**Flood Control Project Maintenance
Levee Inspections**

Fall 2019 Levee Maintenance Deficiency Summary Report

**Flood Control Project Maintenance
Levee Inspections****LMA District Cover Sheet****Fall 2019 Levee Inspection Results****Reclamation District No. 0341 Sherman Island**

Reclamation District No. 0341 Sherman Island

Photo 1 of 3 : UCIP_FA_2019_52254_37654.jpg

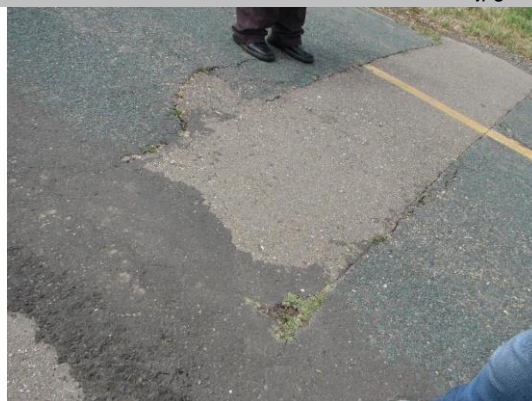
Cut along pipe alignment--unknown repair or maintenance date.

Comment Code						
Inspector Comment						
DS_ID:24111 FS_ID:52254 EP_NO: 1477 Repair Type: Non-Urgent Crossing Status: Found UCIP Comments: 07/06/2016 According to LMA Superintendent, Joel McElroy, the LS pipe section was replaced in about 2005 under the Three Mile Slough Project. No work was completed on crown or WS. (DWR UCIP - O. Magana) 05/05/2009 Dense vegetation limits the inspector's visibility to identify signs of pipe failure (leaks) along the slopes. Recommend removing vegetation along pipe alignment to conduct proper inspection of structure and appurtenances. (DWR UCIP - O. Magana) FIELD_STRUCT_DESC: 10-inch steel irrigation siphon pipe through the levee, 1.8 feet below the crown. 10-inch pipe is encased in 12-inch corrugated metal conduit under crown. Pump is located on landside (LS). Air vent and metal distribution box with gate are located on the LS. Rock revetment placed along the waterside (WS) slope. A 30-foot section of pipe under the crown was replaced and encased in corrugated metal pipe (CMP) under unknown permit. (10-inch pipe authorized under Permit No. 1477, 1950 - L. J. Anderson) [Additional Reference(s): DWR Levee Log, 1992. USACE Sacramento O&M Manual Unit No. 101, February 1962, (HLM 0.50). LMA encroachment station (STA) reference based on Map of Evacuation Route, Reclamation District 341 Sherman Island by Wagner Bonsignore Consulting Civil Engineers, A Corporation dated July 2012, STA 149+00] FS Date: 5/5/2009

Photo 1 of 1 : FA_2019_RD0341_168_34_20190826_00002.jpg

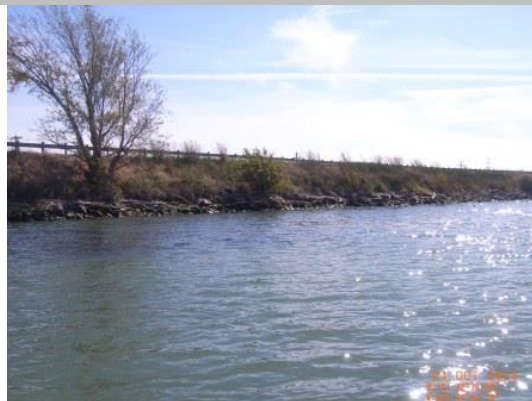
LM Start	4.76	Rating **	A/W	Issue No.	34
LM End	5.01	Issue Type +	Ma	Location *	WS
Category	Supplemental			GPS Latitude/Longitude	
				Start	End
Item	2017 USACE Erosion Survey			38.086603 °	38.083954 °
				-121.707786 °	-121.710589 °
DWR ID	DWR_RD0341_02_f_2018_34				
Comment Code					
Inspector Comment					
2017 Site ID: SAC 7.9 L					
Status: Critical					
2017 Field Notes: Road base exposed in multiple locations. New tree popout observed.					
Site History: 2011 - Large slump section. 2012 - Site extended downstream, upgraded to critical, severe windwave. Slope is very steep and may be effecting the highway on top of the levee.

Photo 2 of 3 : UCIP_FA_2019_22258_37930.jpg

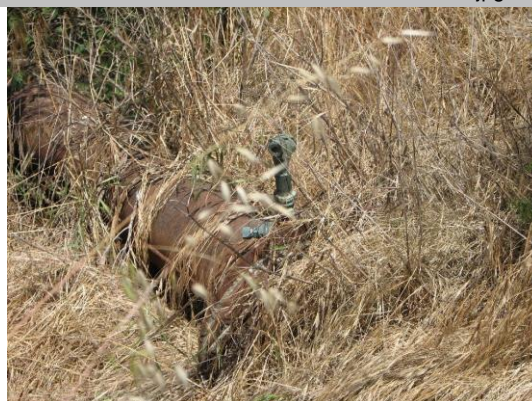
Comment Code					
Inspector Comment					
DS_ID:24074 FS_ID:22258 EP_NO: 11116 Repair Type: Non-Urgent Crossing Status: Found UCIP Comments: Dense vegetation limits the inspector's visibility to identify signs of pipe failure (leaks) along the slope. Recommend removing vegetation along pipe alignment to conduct proper inspection of structure and appurtenances. FIELD_STRUCT_DESC: 1 of 2: 8-inch steel irrigation pipe sleeved through 10-inch pipe through levee, 2.5 feet below the crown. Annular gap grouted. Concrete distribution box with slide gate located on the landside (LS) toe. Air vent located on the waterside (WS). (8-inch sleeved through 10-inch pipe authorized under Automatic Board Order (ABO) issued as Permit No. 11116, 1975 - C. E. & J. E. Upham; distribution box installed and pipe along LS slope removed and replaced with longer 10-inch steel pipe authorized under Permit No. 15372, 1993 - Department of Transportation [Caltrans]) [Additional Reference(s): DWR Levee Log, 1992. USACE Sacramento O&M Manual Unit No. 101, February 1962, (HLM 5.81). LMA encroachment station (STA) reference based on Map of Evacuation Route, Reclamation District 341 Sherman Island by Wagner Bonsignore Consulting Civil Engineers, A Corporation dated July 2012, STA 891+00] FS Date: 5/6/2009

Air vent located on waterward side.

Photo 2 of 3 : UCIP_FA_2019_22263_37961.jpg

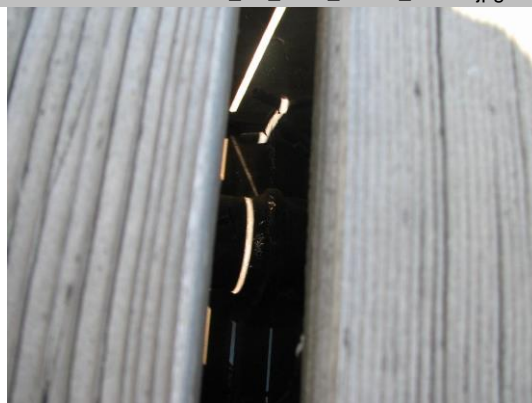
Comment Code						
Inspector Comment						
DS_ID:24081 FS_ID:22263 EP_NO: 892 Repair Type: Non-Urgent Crossing Status: Found UCIP Comments: Need to contact owner to determine status of crossing. Need date of last inspection and confirmation that crossing is still in operable condition. FIELD_STRUCT_DESC: 1 of 2: 12.75-inch steel gas line through the levee, 2.0 feet below the crown. Concrete cutoff wall around pipes at center of levee. Location marker on waterside (WS) slope. Concrete control box and valve pit on landside (LS) slope. Utility marker contact information includes Contact prior to Excavation call 1-800-227-2600 or Emergency Contact 1-800-811-4111. (12.75-inch gas line authorized under Permit No. 892, 1942 - Pacific Gas and Electric Company [PG&E]) [Additional Reference(s): DWR Levee Log, 1992. LMA encroachment station (STA) reference based on Map of Evacuation Route, Reclamation District 341 Sherman Island by Wagner Bonsignore Consulting Civil Engineers, A Corporation dated July 2012, STA 826+00] FS Date: 5/6/2009

Unable to confirm number of pipes.

Photo 2 of 3 : UCIP_FA_2019_22264_37964.jpg

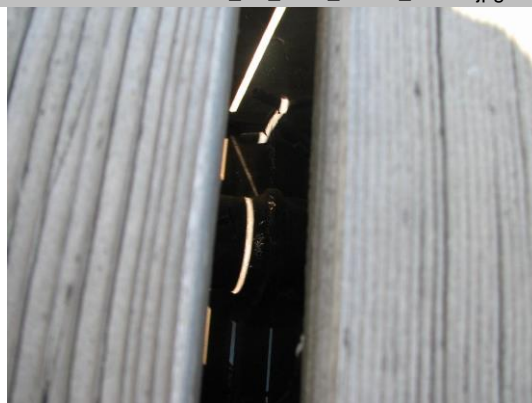
Comment Code						
Inspector Comment						
DS_ID:24234 FS_ID:22264 EP_NO: 892 Repair Type: Non-Urgent Crossing Status: Found UCIP Comments: Need to contact owner to determine status of crossing. Need date of last inspection and confirmation that crossing is still in operable condition. FIELD_STRUCT_DESC: 2 of 2: 12.75-inch steel gas line through the levee, 2.0 feet below the crown. Concrete cutoff wall around pipes at center of levee. Location marker on waterside (WS) slope. Concrete control box and valve pit on landside (LS) slope. Utility marker contact information includes Contact prior to Excavation call 1-800-227-2600 or Emergency Contact 1-800-811-4111. (12.75-inch gas line authorized under Permit No. 892, 1942 - Pacific Gas and Electric Company [PG&E]) [Additional Reference(s): DWR Levee Log, 1992. LMA encroachment station (STA) reference based on Map of Evacuation Route, Reclamation District 341 Sherman Island by Wagner Bonsignore Consulting Civil Engineers, A Corporation dated July 2012, STA 826+00] FS Date: 5/6/2009

Unable to confirm the number of pipe through section of levee.
